Project 85374.01
21 March 2016
85374.01.R.001.Rev1
TW:jlb

Review of Reports – Site Contamination
Arthur Phillip High School and Parramatta Public School
Macquarie Street, Parramatta

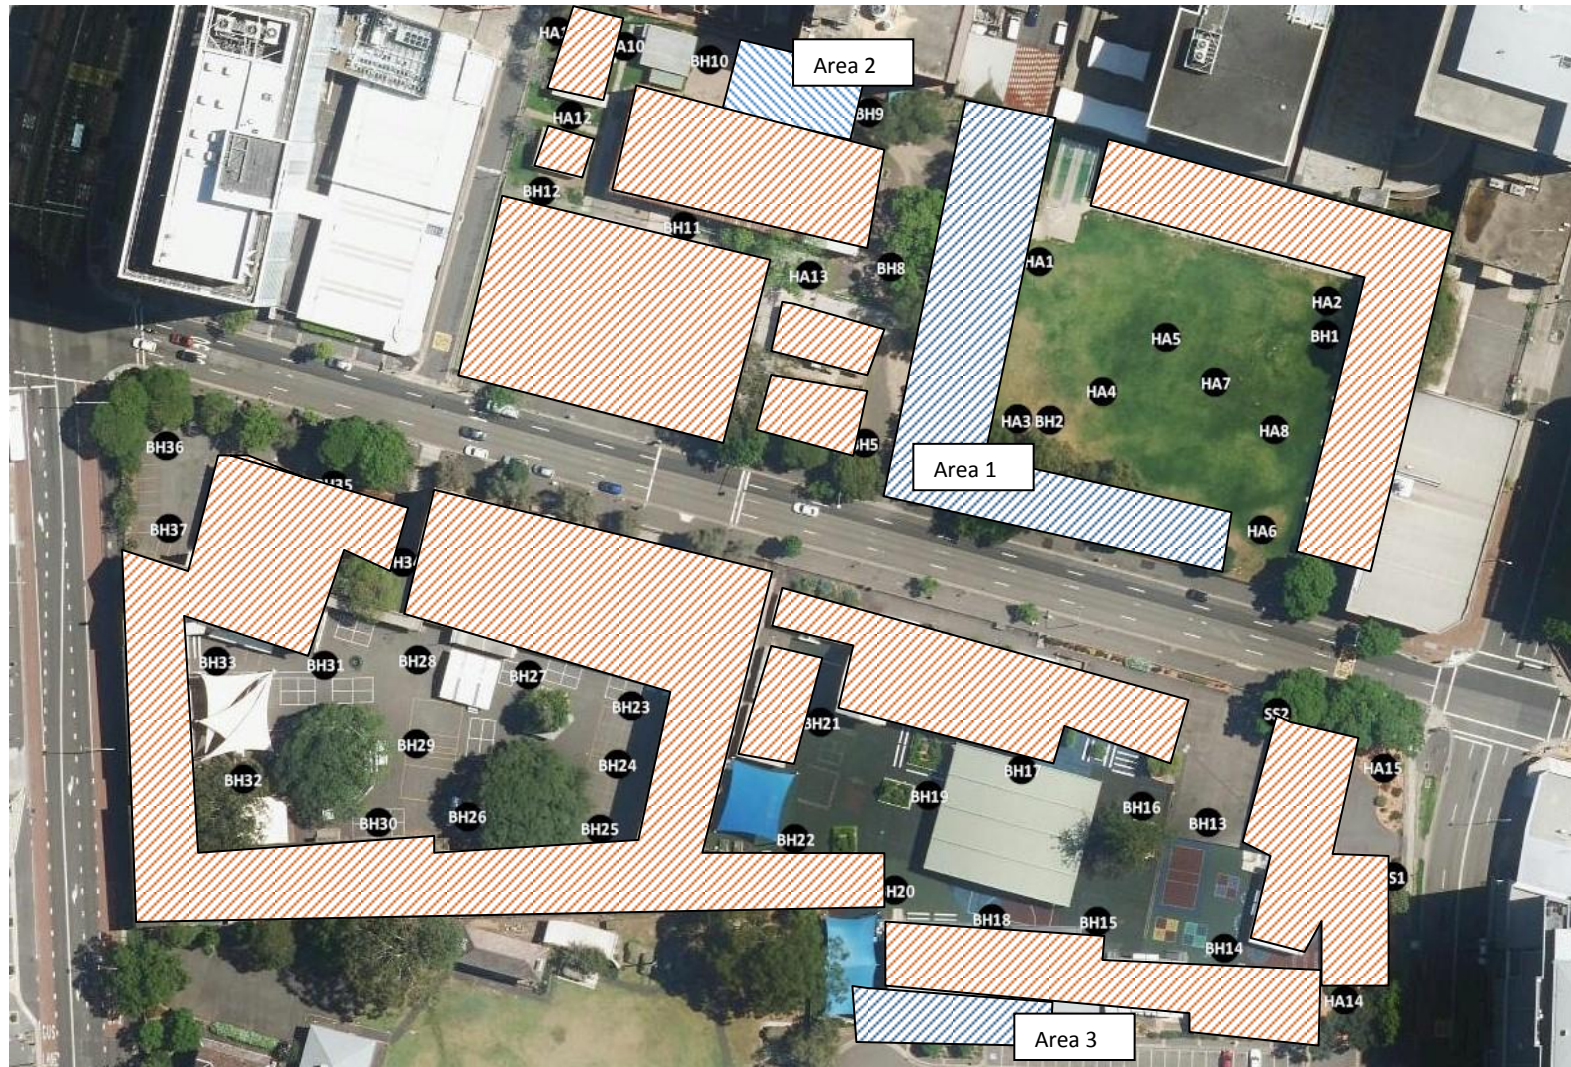
The fieldwork comprised a combination of mechanically advanced boreholes, hand augered boreholes and surface samples, with a total number of 55 sampling locations (refer to AG Drawing Number: 1915-ER-1-C attached). The borehole logs include surface levels but not coordinates, so relocating the sampling points would need to be based on the locations shown on the figures in AG (2015a) which can prove to be problematic.

The filling in the south site was encountered to depths of between 0.4 m and 0.7 m bgl and comprised brown to grey gravelly clay/silty clay with foreign materials such as igneous gravel and bitumen. Fragments of ACM were observed on the ground surface in the south west of the PPS site (HA16) (refer to AG Drawing Number: 1915-ER-1-C attached), however, the condition of the fragments is not given.

Thirty one samples were analysed for asbestos, however, ten of the samples analysed were natural soils and would not be expected to contain asbestos. Of the remaining 21 samples (17 from the north site and four from the south site – Tables 1 and 2 above) AG (2015a) states that three samples exceeded the SAC, however, it is not stated how the concentrations of asbestos %w/w were calculated. Asbestos was reported in the laboratory certificate to be present in the following four samples (refer to AG Drawing Number: 1915-ER-1-C attached):

- HA9-0.0-0.2 – chrysotile, amosite and crocidolite in fibre cement fragments, and chrysotile and amosite in loose fibre bundles (north site – filling);
- HA16-0.0-0.2 – chrysotile, amosite and crocidolite in fibre cement fragments and in loose fibre bundles (south site – filling);
- BH4-0.0-0.1 – chrysotile and amosite in fibre cement fragments (north site – filling); and
- BH12-0.0-0.1 – chrysotile in loose fibre bundles (north site – filling).

AG (2015b) states that soils impacted by friable asbestos (AF/FA – asbestos fines / fibrous asbestos) were present in three locations; HA9, HA16 and BH4. However, the asbestos identified in the sample from BH4 was not in a friable form; and friable asbestos was also recorded in a sample from BH12. To summarise the results as reported by AG (2015a), as corrected by the contents of the laboratory certificate of analysis, asbestos / asbestos impacted soil was recorded in the following locations (refer to AG Drawing Number: 1915-ER-1-C attached):

- HA9 – non-friable on the surface and, friable and non-friable at 0.0-0.2 m depth – north site; HA16 - non-friable on the surface and, friable and non-friable at 0.0-0.2 m depth – south site;
- BH4 – non-friable at 0.0-0.1 m depth – north site;
- BH7 – non-friable on the slope surface – north site; and
- BH12 - friable at 0.0-0.1 m depth – north site.

Additional asbestos quantification works in areas of identified asbestos are proposed by AG. It is proposed by AG to excavate test pits on a 10 m grid in three areas (Areas 1 to 3), however, the rationale for the 10 m grid is not provided and the three areas do not include BH12. The National Environment Protection Council *National Environment Protection (Assessment of Site Contamination) Measure* 1999, as amended 2013 (NEPC, 2013) refers to the WA DoH *Guidelines for the Assessment, Remediation and Management of Asbestos-Contaminated Sites in Western Australia*, 2009 (WA, 2009) for the investigation, assessment and management of asbestos in soil. WA (2009) includes sampling densities which have not been referred to in the RAP.

- Further statistical analysis of the lead concentrations recorded in filling and natural soils; and
- Further assessment of the potential extent of asbestos impacted filling identified to date.

- Updating to include the requirements of WA (2009);
- Reassessment of the extent of the areas requiring additional asbestos quantification works and areas of remediation;
- Inclusion of the requirements for the assessment and consolidation and isolation of AF/FA impacted material; and
- Updating of the validation plan and inclusion of RAC.
